UNITED STATES PATENT AND TRADEMARK OFFICE

10/817,620

Office Action Summary	Application No. 10/817,620	Applicant(s) WOODS, CARL	
	Examiner JOY WATSON	Art Unit 1792

DETAILED ACTION

FIG. 3

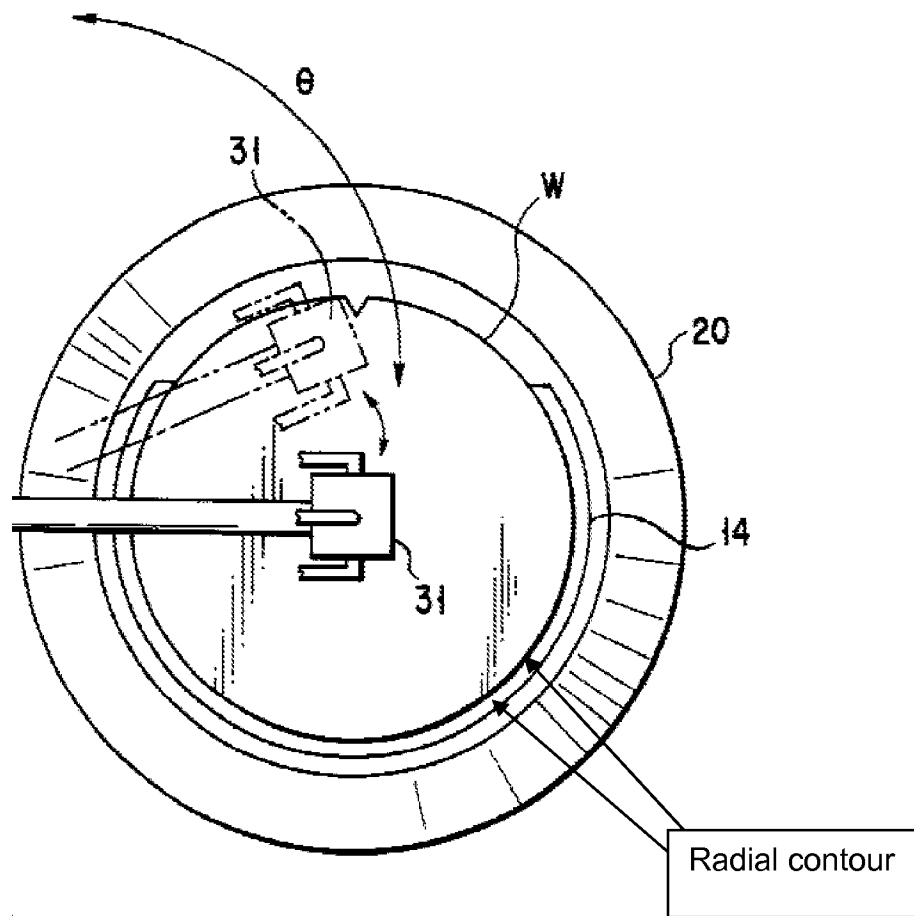
In response to applicant's argument that feature 14 of '479 encircles the entire wafer the examiner respectfully disagrees (Fig. 3). Feature 14 encircles the wafer approximately 270 degrees on the lower portion of the page.

'479 teaches the apparatus according to Claim 1, and additionally teaches that the docking surface (13 and 14) has a radial contour that matches a radial contour of the substrate (W) where the radial contour of the docking surface does not fully encircle the substrate (col. 6, lines 20-32, Fig. 2) (See Fig. 3 below).

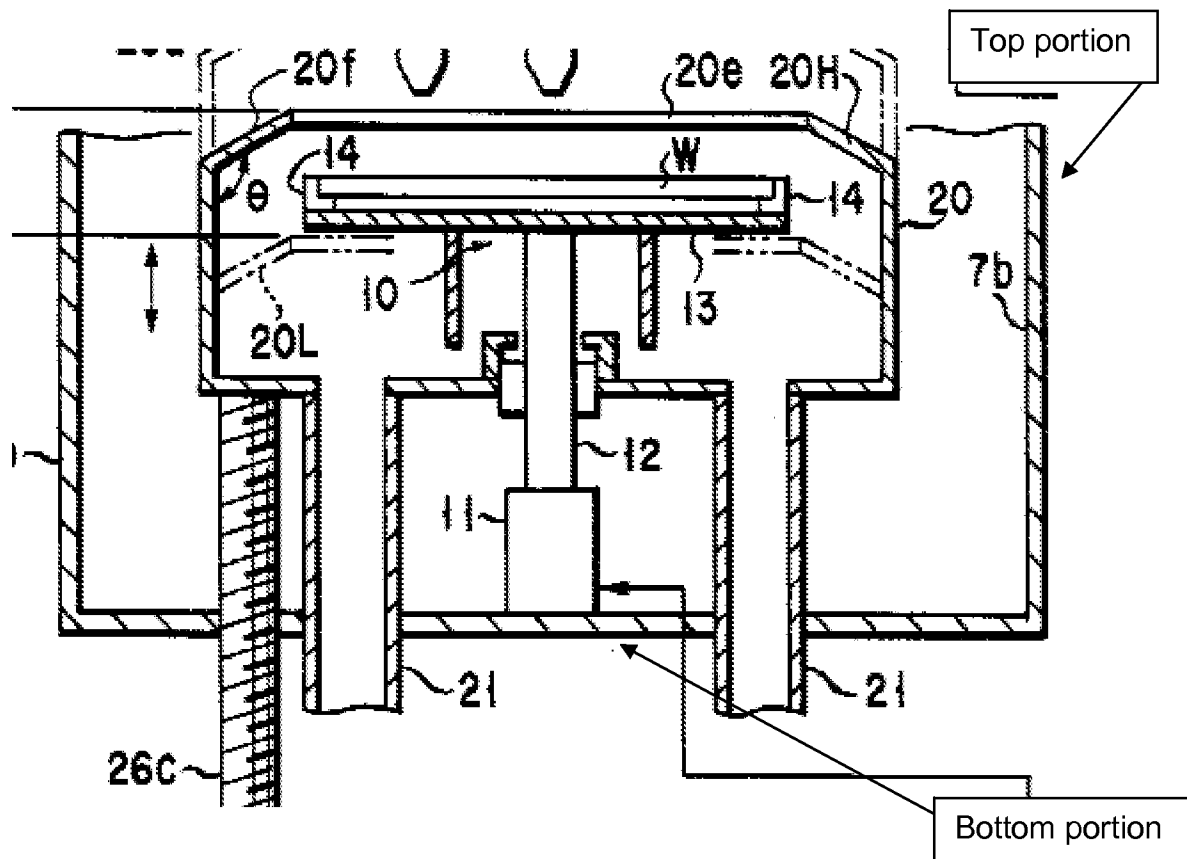
'479 teaches an apparatus for processing a substrate with a fluid meniscus to be applied to a surface of the substrate (abstract), comprising: a docking surface (13 and 14) oriented adjacent to and beside an edge of the substrate (W), the docking surface (13 and 14) being coplanar with the substrate (W) (Fig. 13) (col. 6 lines 20-32, Fig. 2).

'479 teaches the apparatus a coupon magazine (7b) for holding the docking station (20) that includes the docking surface (13 and 14) (Fig. 13, col. 6 lines 20-32). The transition interface is the space defined by one of the interior wall of the coupon magazine while the bottom wall holds the docking surface (13 and 14). The coupon magazine (7b) has a top and bottom portion (see figure below). '479 teaches the apparatus according to Claim 1, and additionally teaches that the docking surface (13 and 14) has a radial contour that matches a radial contour of the substrate (W) where the radial contour of the docking surface does not fully encircle the substrate (col. 6, lines 20-32, Fig. 2) (See Fig. 3 below). "Providing a transition interface to allow the fluid meniscus to enter and exit the surface of the substrate, the transition interface being spaced apart from the substrate" is intended use. It has been held that a recitation with respect to the manner in which a claimed apparatus is intended to be employed does not differentiate the claimed apparatus from a prior art apparatus satisfying the claimed structural limitations. *Ex parte Masham*, 2 USPQ2d 1647 (1987).
